CITY PLANNING COMMISSION

1. Negative Declaration
2. Special Permit to allow an integrated architectural feature consisting of an illuminated colored band on an Arco station

LOCATION: 1399 Florin Road

APPLC. NO. 82-103

FLORIN ROAD
 SITE PLAN
 SCALE: 1/8" = 1'-0"

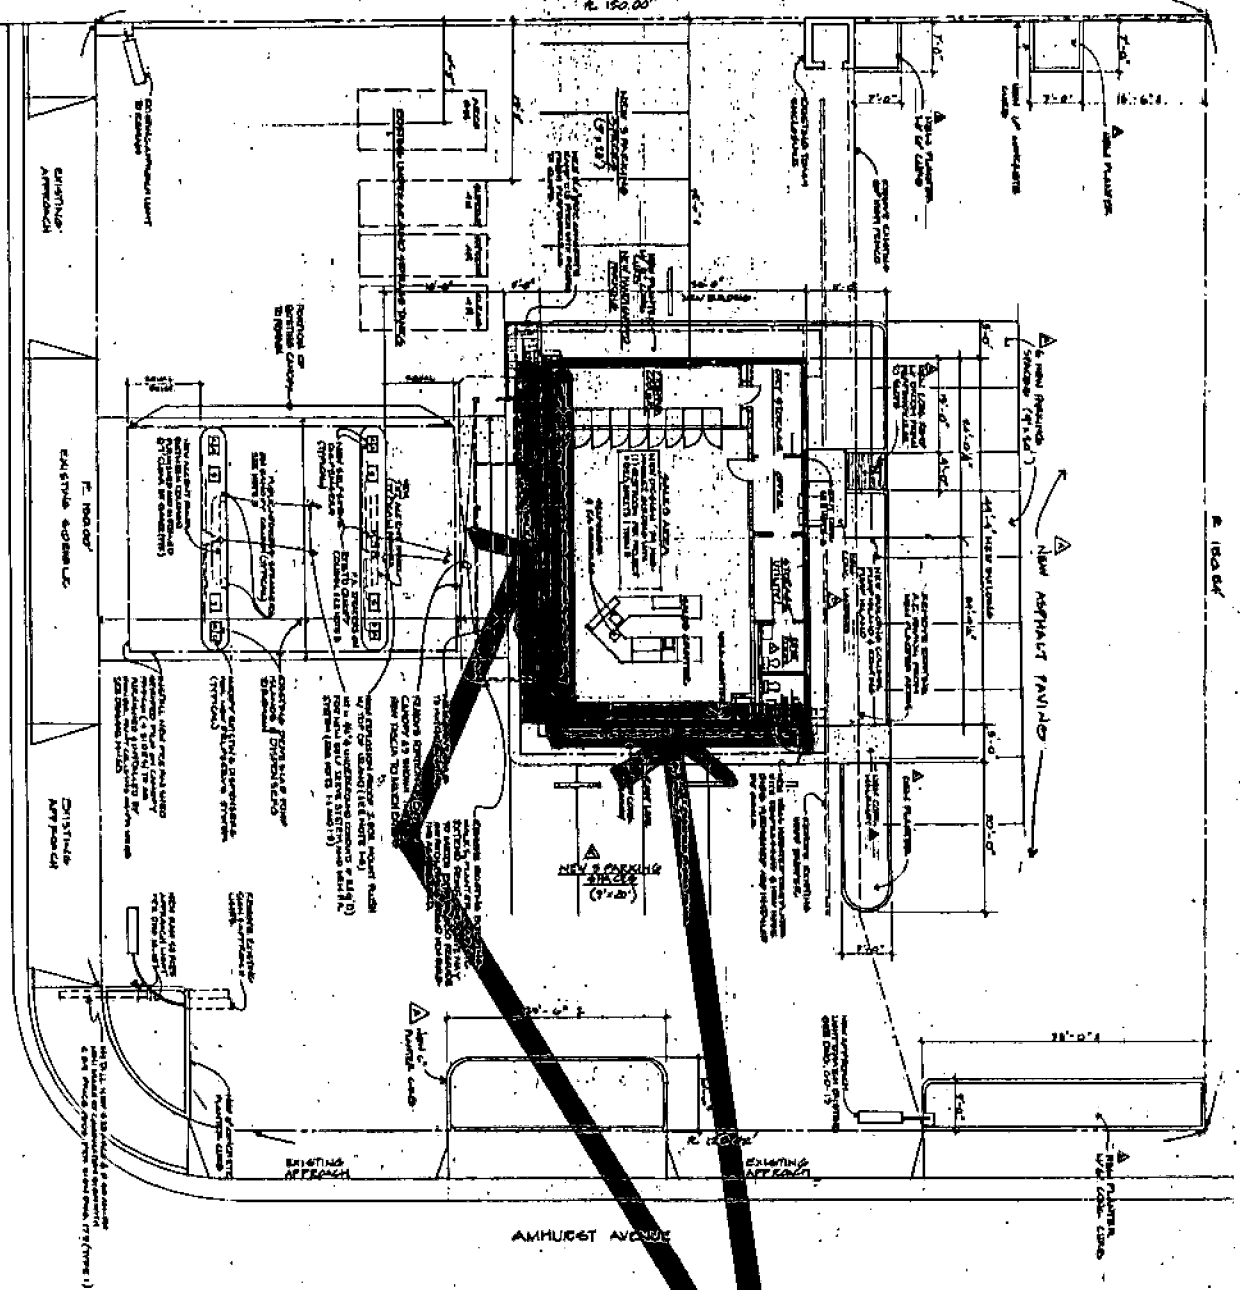
The applicant's plans indicate a total of 4 signs totaling 320 sq.ft. in area (including the lighted facia). To comply with the Sign Ordinance specifications for the C-2 zone, the applicant will have to reduce the total square footage by 62 feet to a maximum of 258 square feet.

2. Applicant's request: The applicant is proposing to add an internally illuminated facia or band around the perimeter of the service station on the south and east elevations.

Staff finds that since this fascia is defined as part of the signage that the total square footage of all signs, including the lighted fascia, should not exceed the total allowable signage for this zone. Staff cannot support this request because the resultant increase in square footage, as requested, would be a circumvention of the maximum square footage permitted for this zone.

Staff finds that the proposed internally illuminated fascia is similar in nature to those types of lighting or signage prohibited by this section and therefore should not be allowed.

1. Ratification of the Negative Declaration.
2. Denial of the Special Permit based upon the following findings of fact;
 - a. The granting of the special permit would be contrary to the purpose of the Sign Ordinance in that it would result in the creation of excessive and confusing sign displays and would not act in such a way as to preserve and improve the appearance of the City as a place in which to live and to work.
